RAPID UPDATE

Rapid Update 623 Grecale – ITM Software Update

DATE: MAY 4 2023

(OPT LSA) Reactivation (F14 Fuse Restore + VC Writing)

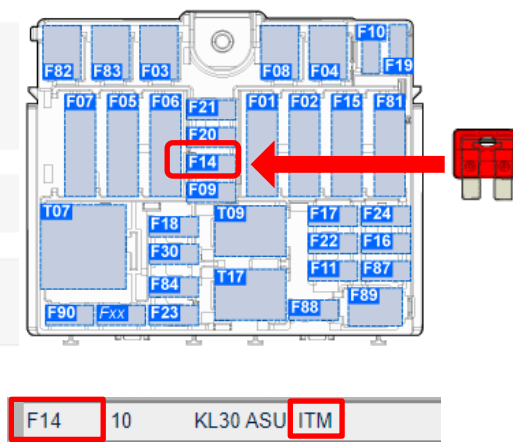
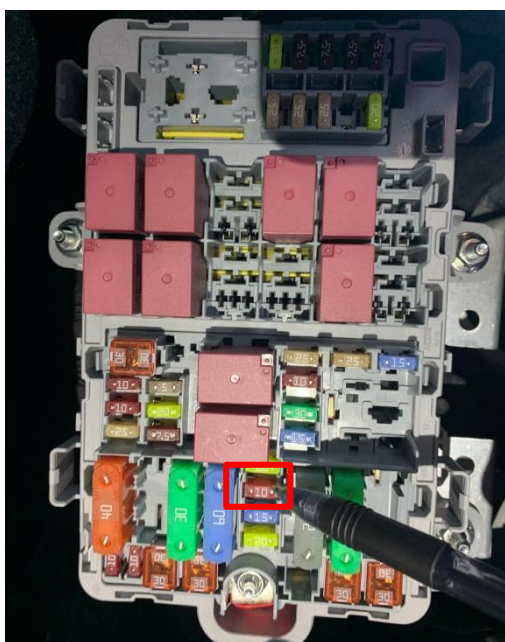
1. Access the Rear Distribution Unit (RDU) and re-install the **F14 10A** fuse that was removed previously per Rapid Update 599, indicated in the pictures below:

2. Write the new **"Vehicle Configuration"** via BCM procedures using the MD-EVO.

3. Clear any leftover DTCs.
4. Continue with the SW Update below:
5. Exit the EVO application then restart and proceed with the SW update below.
